OBSOLETE PART NOTIFICATION

November 1, 2016

After this date, Blue-White will no longer manufacture this style Tube Assembly.

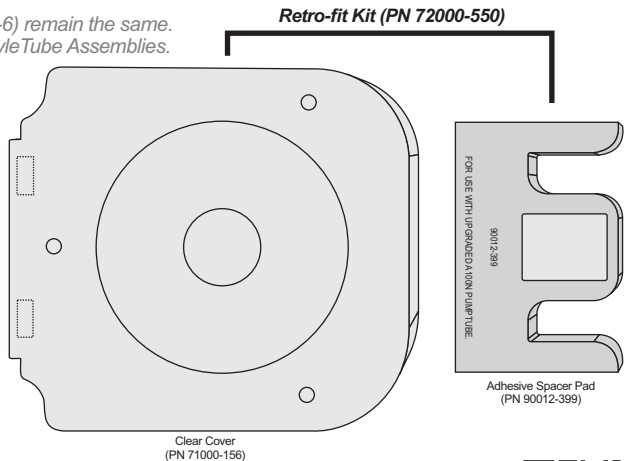
Step 3) Place Adhesive Spacer Pad (PN 90012-399) onto Pump Head *

Step 4) Place new Clear Cover (PN 71000-156) onto Pump Head

Retro-fit Kit
(PN 72000-550)
REQUIRED for
use of **NEW**
Tube Assembly
on **OLD** Pump Head

Kit includes
Adhesive Spacer Pad
(PN 90012-399)
and Clear Cover
(PN 71000-156)
